| ITEM-7               | GATEWAY DETERMINATION - IBM SITE 55<br>COONARA AVENUE, WEST PENNANT HILLS<br>(1/2018/PLP)   |  |

This report recommends that Council write to the Department of Planning and Environment and request that a revised Gateway Determination be issued for the planning proposal applicable to land at 55 Coonara Avenue, West Pennant Hills (IBM Site) (1/2018/PLP).

# Planning Proposal PP\_2017\_THILL\_006\_00 to amend The Hills Local Environmental Plan 2012

Figure 3 Proposed Land Zoning Map

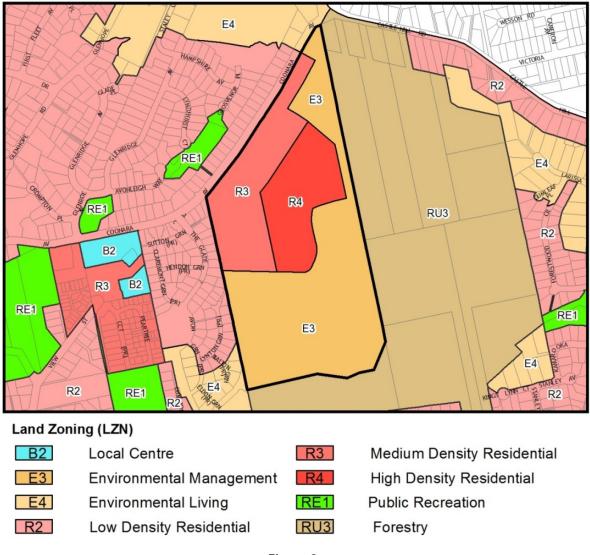
The use of the RE1 Public Recreation zone is not supported. Whilst this zone would recognise the intended function and future public ownership of the land proposed to be dedicated, it could create a potential acquisition liability for Council. Specifically, under the provisions of the *Environmental Planning and Assessment Act 1979* (Section 27) if land is reserved for the purposes of public open space a relevant acquisition authority must be identified. Council is the identified acquisition authority for land zoned RE1 Public Recreation.

- R3 Low Density Residential (Mixed Housing Precinct);
- R4 High Density Residential (Residential Flat Building Precinct & common areas); and
- E3 Environmental Management (Existing Vegetation Area and land identified for dedication as open space).

The recommended application of land zoning is shown in Figure 3 below.

- Requires the site to be rezoned from B7 Business Park to R3 Medium Density Residential, R4 High Density Residential, and E3 Environmental Management consistent with Figure 3 in the report;

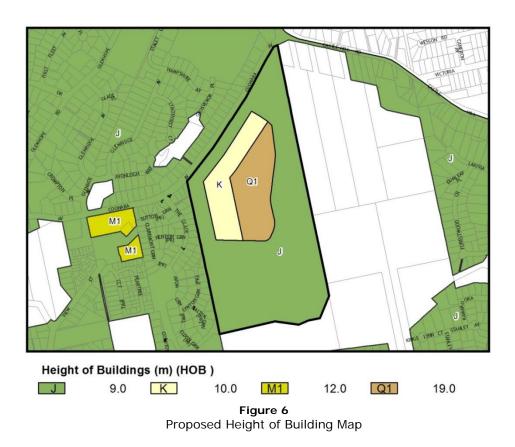
The proponent's design concept illustrates that the residential flat building precinct will have a maximum height of six (6) storeys and the mixed housing precinct will have a maximum height of three (3) storeys with the housing product along the Coonara Avenue frontage of the site limited to a height of two (2) storeys. The Gateway Determination requires the planning proposal to be amended to include a height of buildings map.

The current maximum height applying to the site under LEP 2012 is 22 metres. To facilitate the intended built form and provide certainty for the community it is recommended that a maximum height of nine (9) metres be applied to the Coonara Avenue frontage and the majority of the site of the site, which is consistent with the maximum building heights currently permissible in the surrounding residential locality. A maximum height of 10 metres is recommended for remaining part of the proposed mixed housing precinct and 19 metres for the proposed residential flat buildings location.

The recommended application of maximum height of buildings mapping is shown in Figure 6.

- Requires Minimum Lot Size mapping for the site of 700m<sup>2</sup>, 1800m<sup>2</sup> and 2 hectares consistent with Figure 5 in the report;
  - Requires Maximum Height of Building mapping of 9 metres, 10 metres and 19 metres consistent with Figure 6 in the report; and

Figure 10: Location of proposed public access within future development

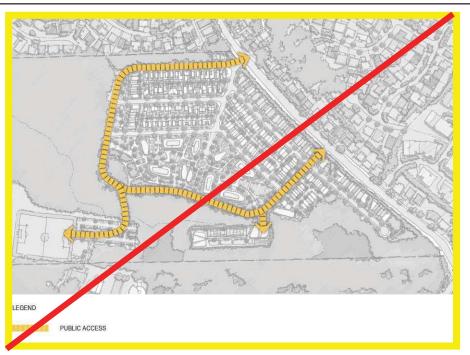
- •Any future development on the site shall be publicly accessible from Coonara Avenue.
- •The access road (loop road) identified as the yellow dotted line in Figure 10 is to be dedicated to Council as a public road and shall be constructed to Council's specifications for local roads contained within The Hills Shire Council Subdivision and Development Design Guidelines
- •Public access should be located in accordance with Figure 10.
